The Heights Building Phase 2

Transportation Commission – June 30, 2022

Planning Commission – July 7, 2022

Design Revisions

Plan View: Field (Heights Level 1)

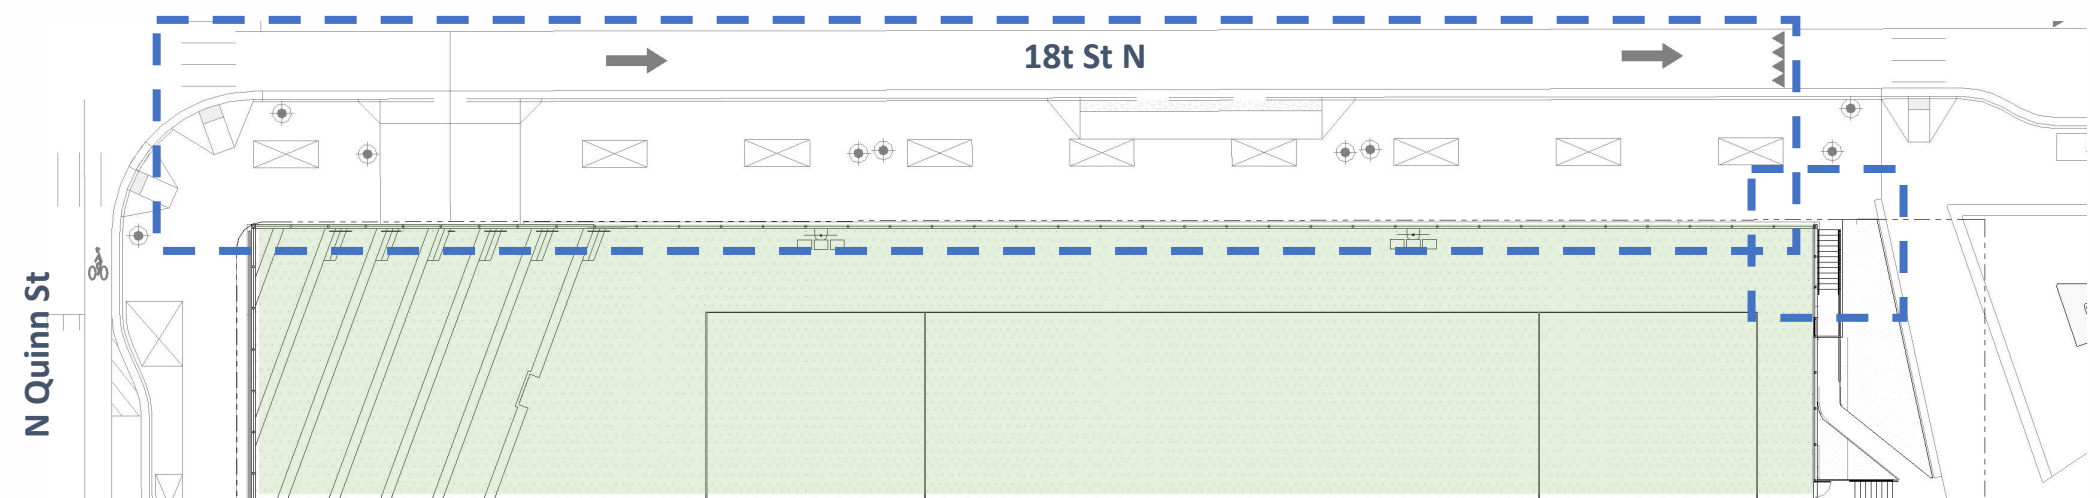
- Revised 18th St N streetscape
 - Maintains existing street width and parking lane adjacent to APS frontage
 - Adds continuous elevated planting strip with trees and other plantings
 - Reduces sidewalk clear width to 10'-0"
- Geometry change at stair from 18th St N to field
- Additional detail on finishes at covered entrance to building Level G1
- Façade treatments along 18th St N
- Added planting strip at N Quinn St adjacent to railing

Enlarged Site Section at 18th St. Near Park

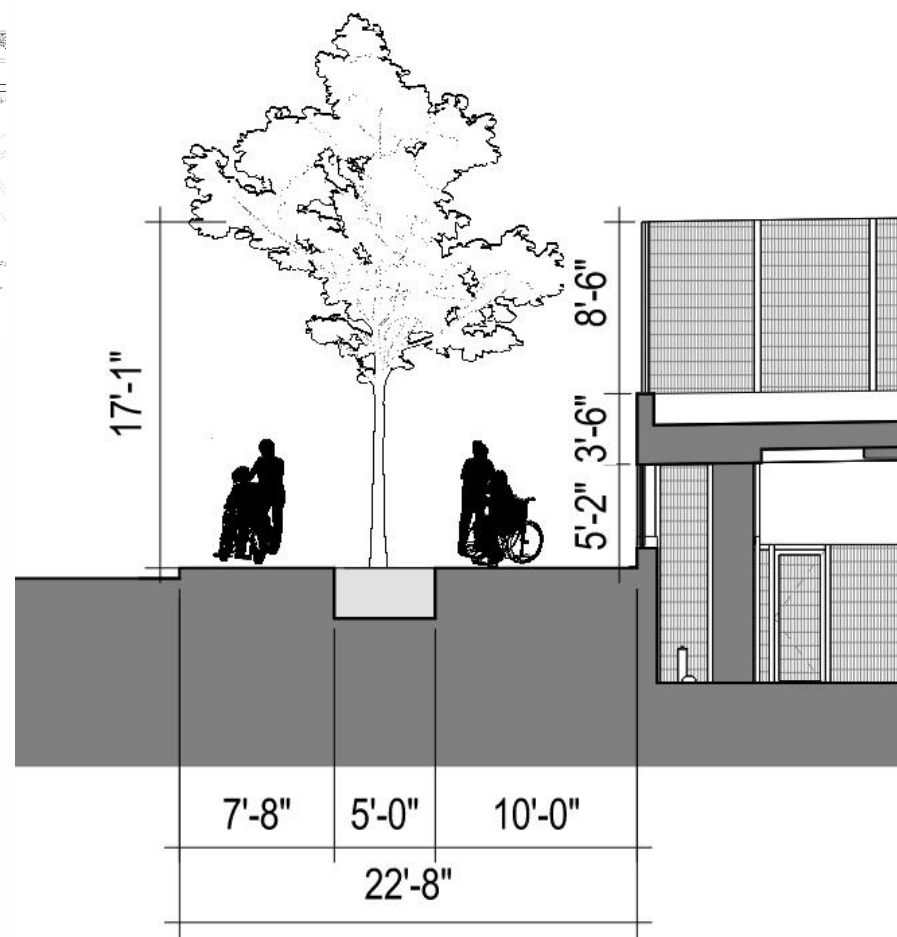
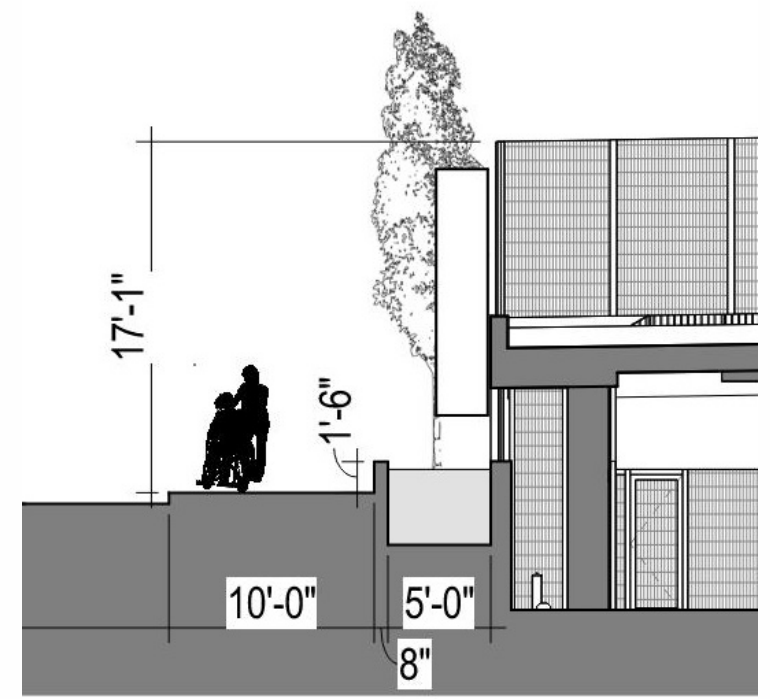
Reduces existing roadway width, removing parking lane along APS frontage

Maintains existing roadway width and parking lane along APS frontage

Covered Entrance to Building Level G1

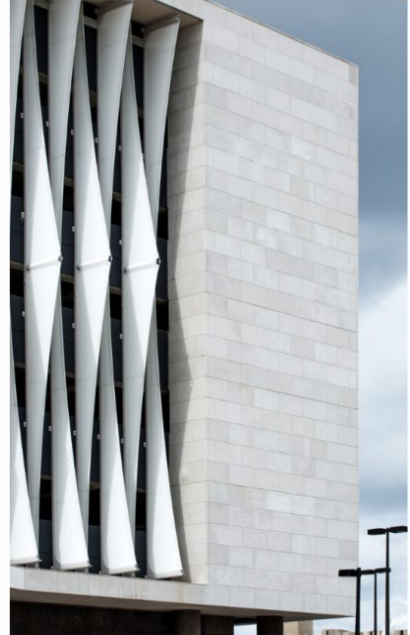
Proposal: a high-quality white mineral coating applied to the concrete wall and soffit at covered entrance.
